# UNITED STATES PATENT AND TRADEMARK OFFICE

APPLICATION NO.	FILING DATE	FIRST NAMED INVENTOR	ATTORNEY DOCKET NO.	CONFIRMATION NO.
10/717,974	11/21/2003	Bo Yeon Kim	9988.081.00-US	8004

**Office Action Summary**

## **DETAILED ACTION**

REPLACEMENT SHEET

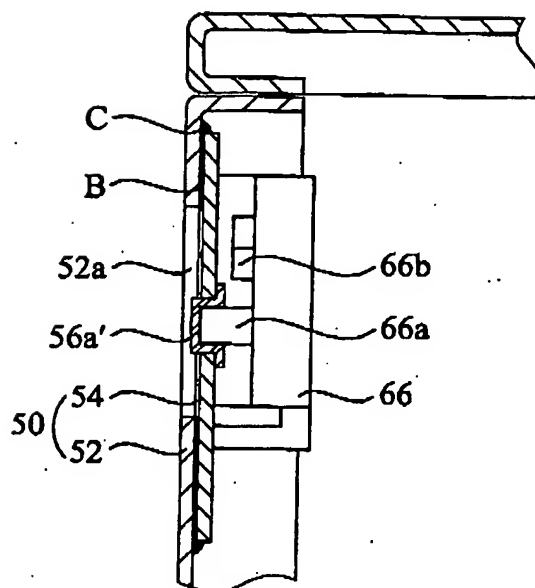
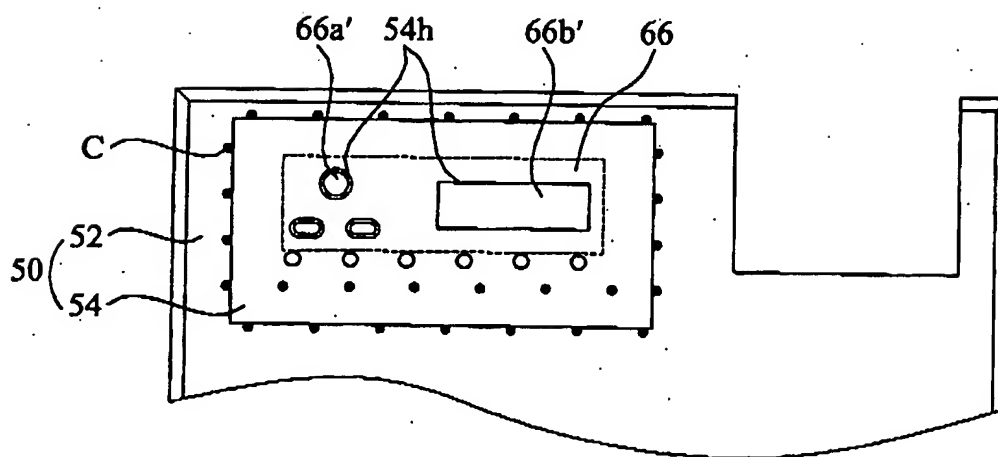
1. The drawings were received on July 20, 2005. These drawings are disapproved by the examiner for the following reason: after review and consideration, it appears that the proposed reference corrections may not be accurate. As currently amended, reference no. 66b is directed to the "display" and reference no. 66a is directed to the "controls". When comparing amended figure 5 with respect to original figure 6 [rear view of fig. 5 embodiment], it appears that the "controls" [66a] depiction is higher in elevation than the "display" [66b] depiction. When compared to amended figure 5, the referenced "display" would be higher in elevation than the referenced "controls". The examiner questions the referencing of the elements in question [should the references be reversed?].

Not Approved  
John 9/20/05
